ADDENDUM NO. 03

August 14, 2026

Oak Hill United School Corporation – Multi-School MEP Improvements
405 South Washington St, Swayzee, IN 46986
7760 Delphi Pike, Converse, IN 46919
600 Walnut St, Converse, IN 46919

Addendum Three (AD.03) to the drawings and specifications prepared by Gibraltar Design for **Mechanical Improvements Across Three Schools** for Oak Hill United School Corporation Converse, Indiana.

3
A-410
3/4" = 1'-0"

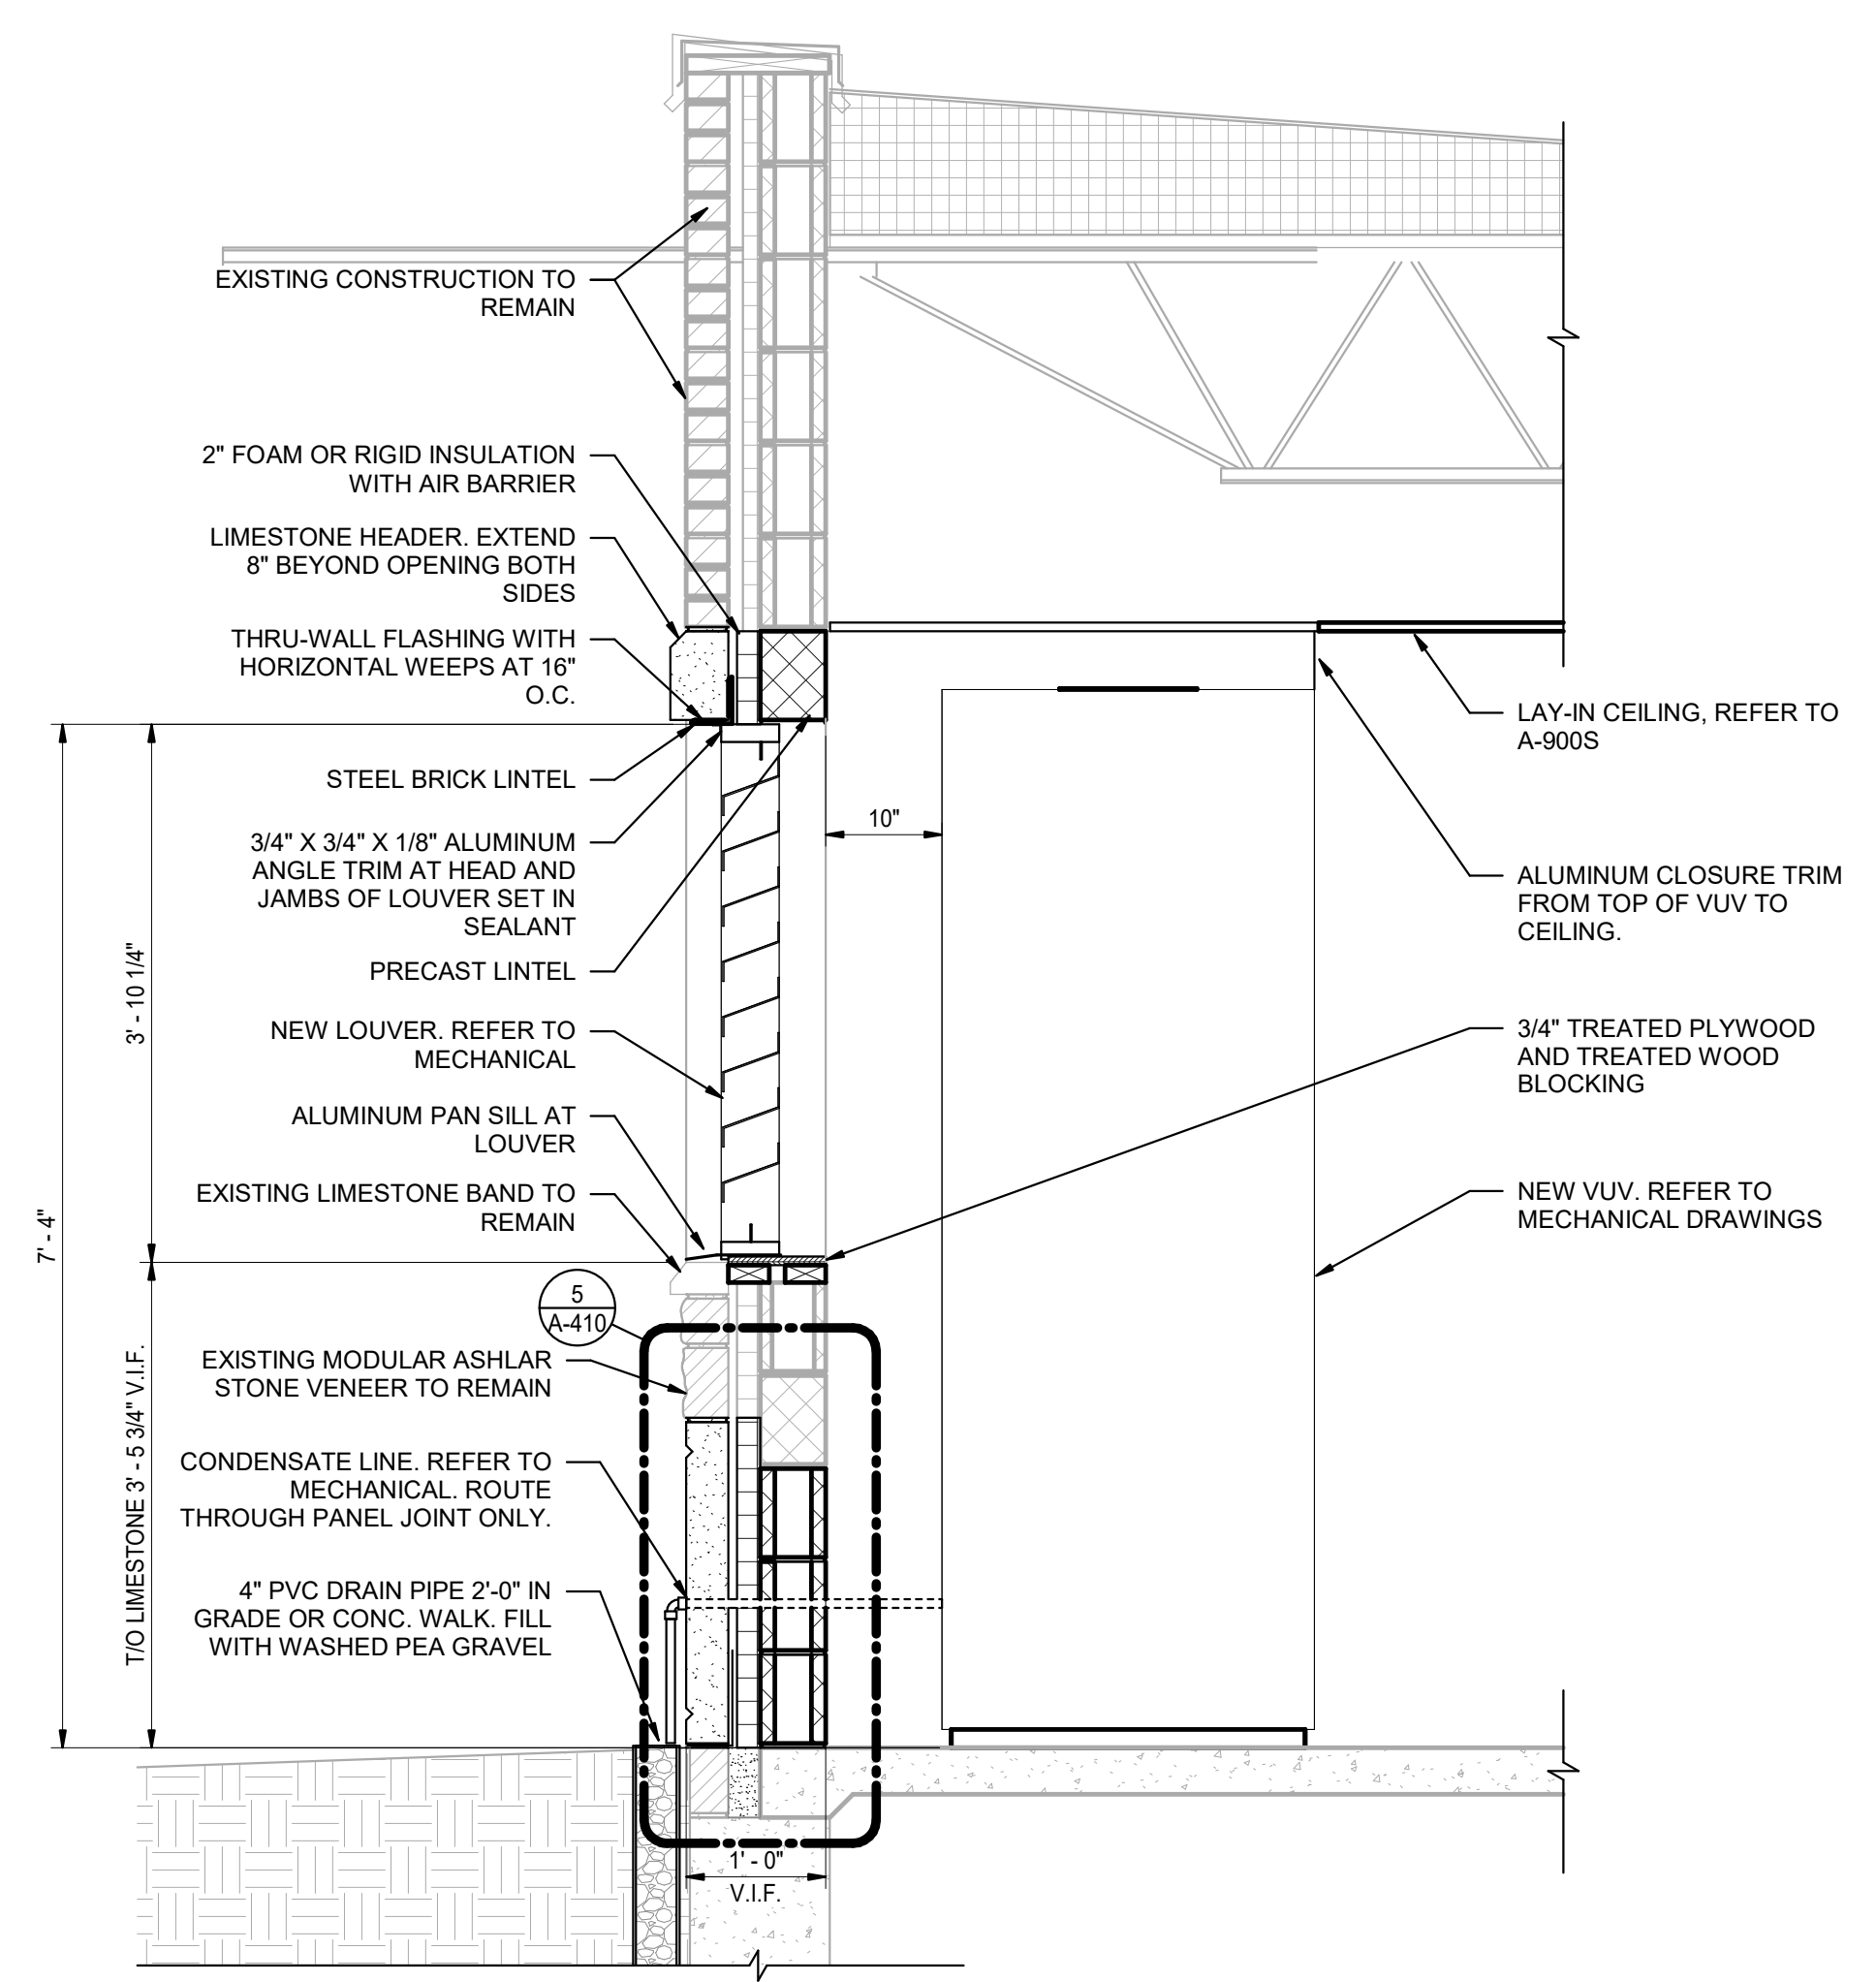
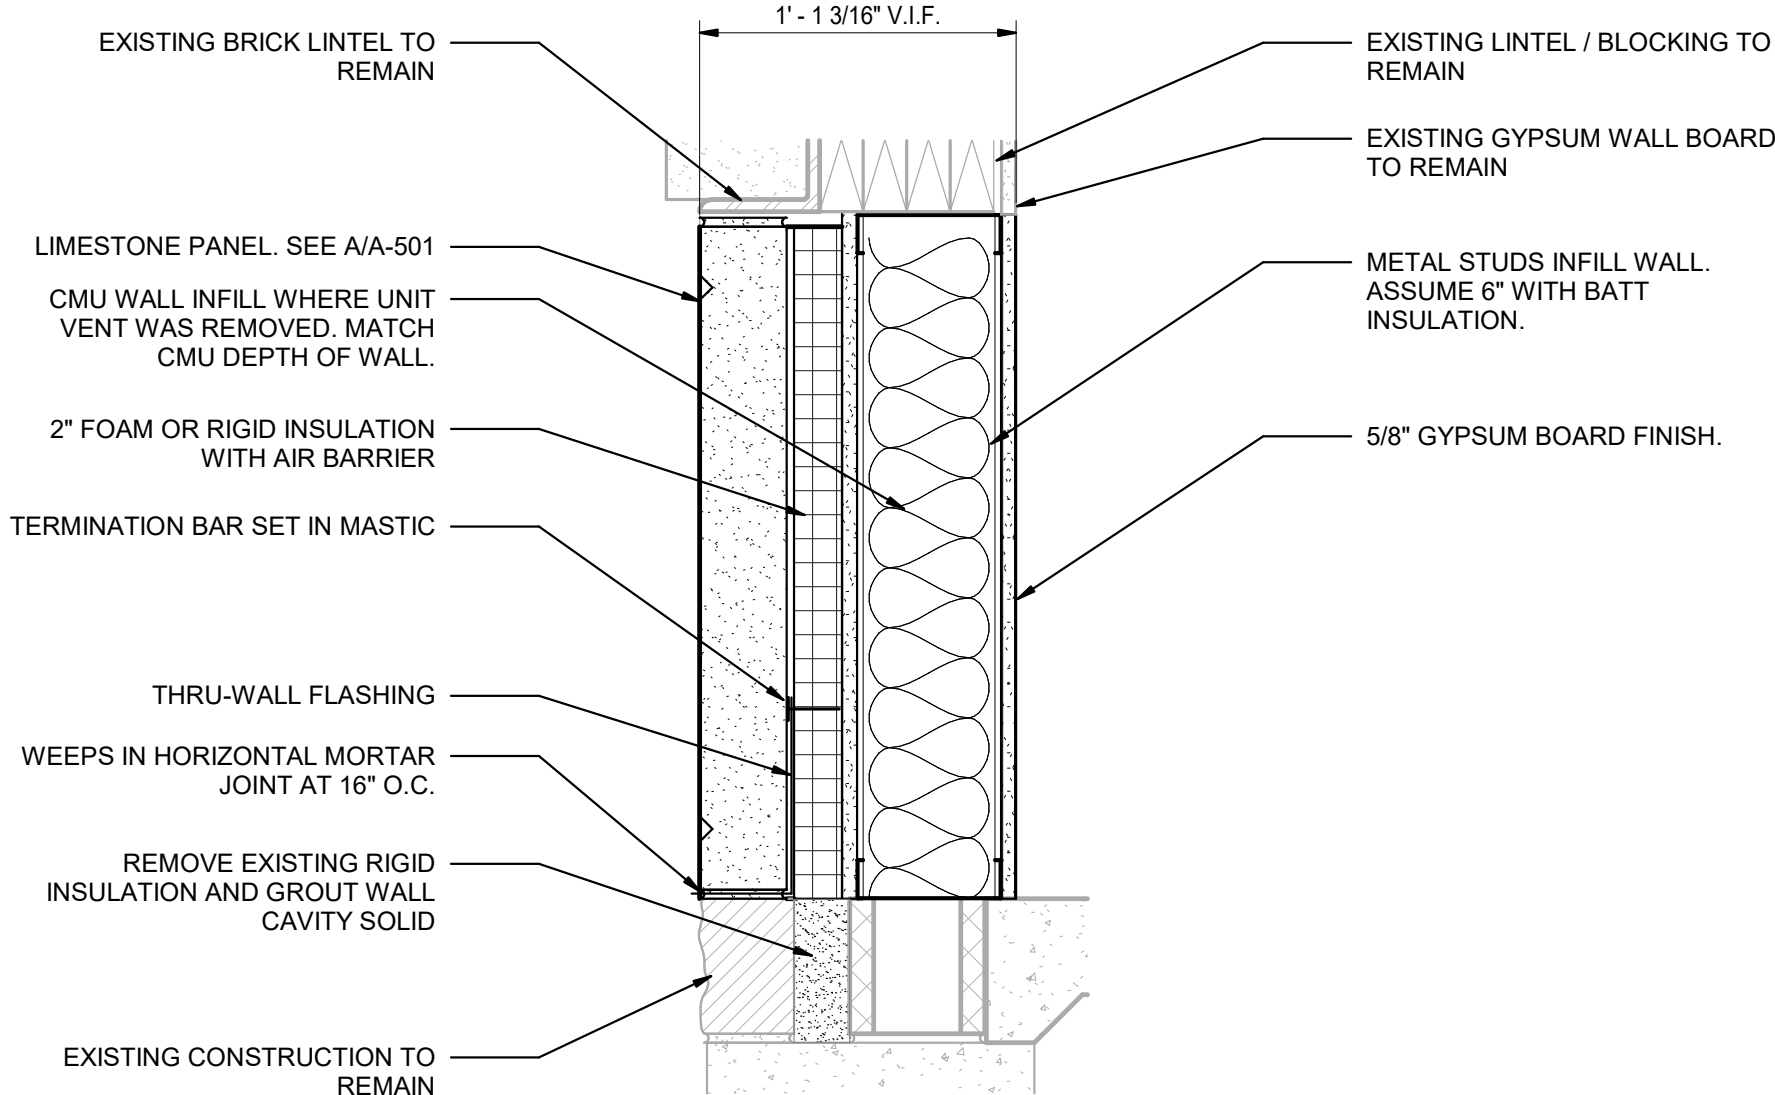
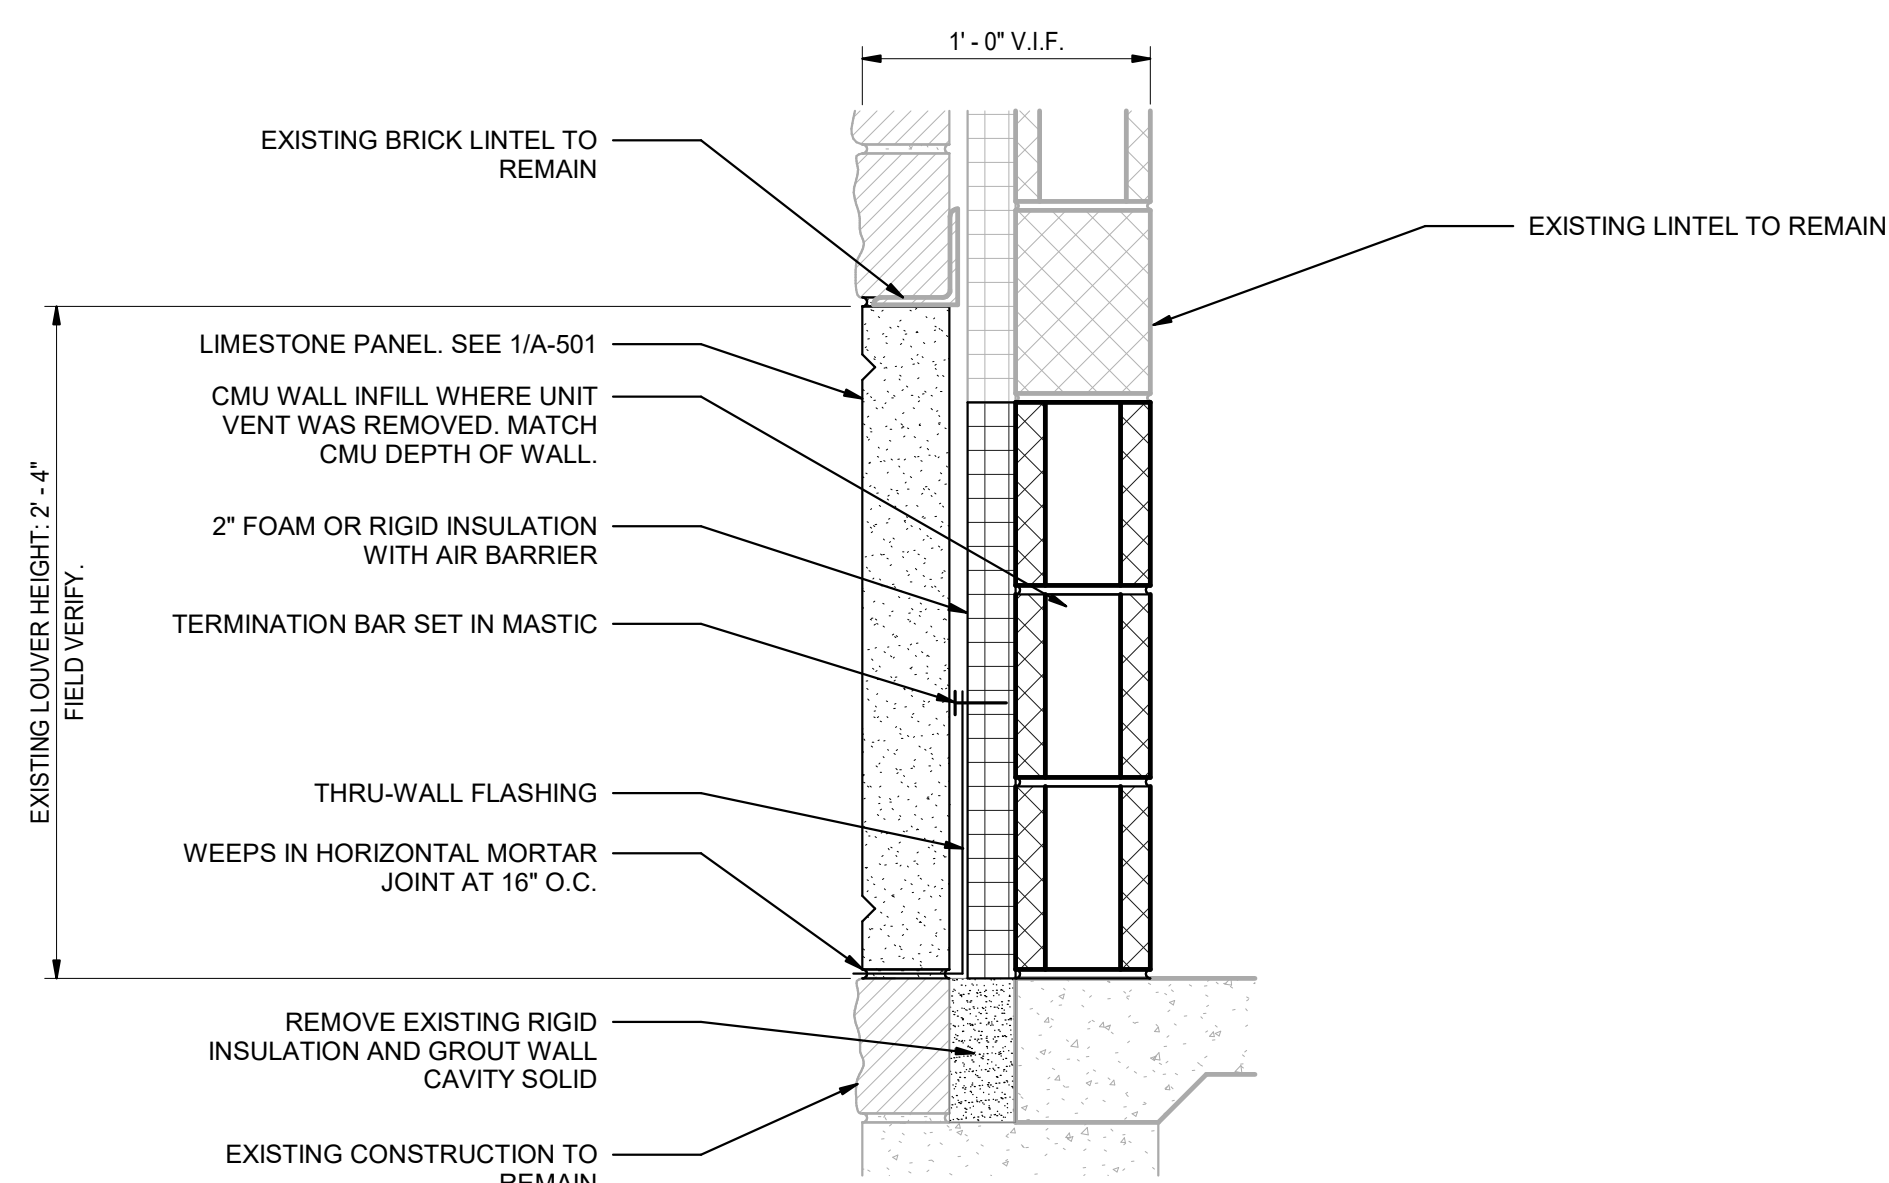
9. Sheet A-410

- A. Refer to revised, full-size drawings, included in this Addendum, for revisions.
